Planning Commission Staff Report

FINE TUNING ZONING AMENDMENTS

Fences, Park Strips, and TSA and R-MU Setbacks PLNPCM2013-00291

Hearing date: February 26, 2013

ILLUSTRATION - I SIGHT DISTANCE TRIANGLE

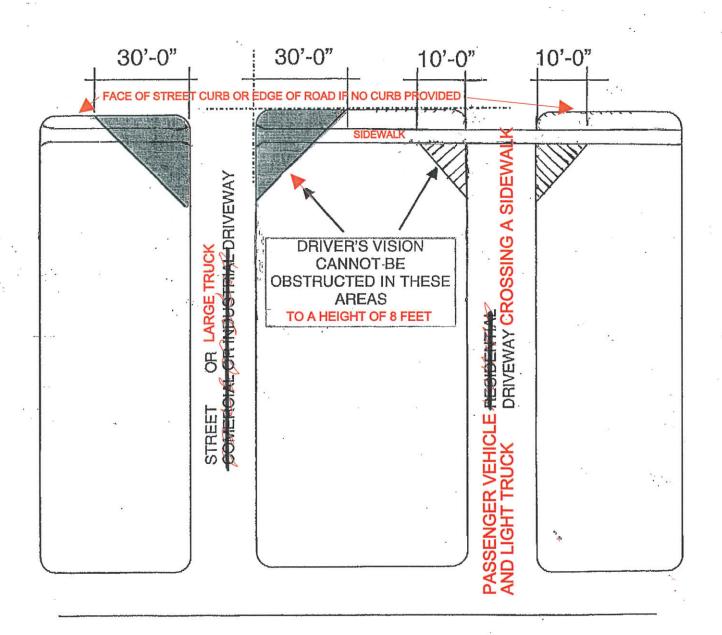
The definition for "**sight triangle**" would be modified so it is based on the curb or edge of roadway rather than the property line, which is most often located back from the curb and roadway. The Transportation division would prefer to administer it this way because the location of property lines often causes additional, unneeded area in the sight triangle and can be bothersome to locate. An updated sample diagram is also proposed.

SECTION 4. <u>Amending text of Salt Lake City Code</u> Section 21A.62.050.I. That Section 21A.62.050.I of the Salt Lake City Code (Zoning: Definitions: Illustrations of Selected Definitions: Sight Distance Triangle) shall be, and hereby is amended as follows:

SIGHT DISTANCE TRIANGLE: A triangular area formed by a diagonal line connecting two (2) points located on intersecting right of way lines (or a right of way line and the edge of a driveway). when measured as follows:

- a) For Corner Lots: extending thirty feet (30') from the intersecting line of each street face of curb, or edge of roadway where curbing is not provided. Proposals in commercial and industrial districts which have a minimum front or corner side yard setback requirement, that seem to allow encroachment into the sight distance triangle, shall be reviewed through the site plan review process by the city's Development Review Team.
- b) For Street Or Large Truck Driveways: extending thirty feet (30') from each intersecting edge of the driveway and street face of curb, or edge of roadway where curbing is not provided,
- c) For Passenger Vehicle And Light Truck Driveways Crossing A Sidewalk: extending ten feet (10') from each intersecting edge of the driveway and back edge of the sidewalk.
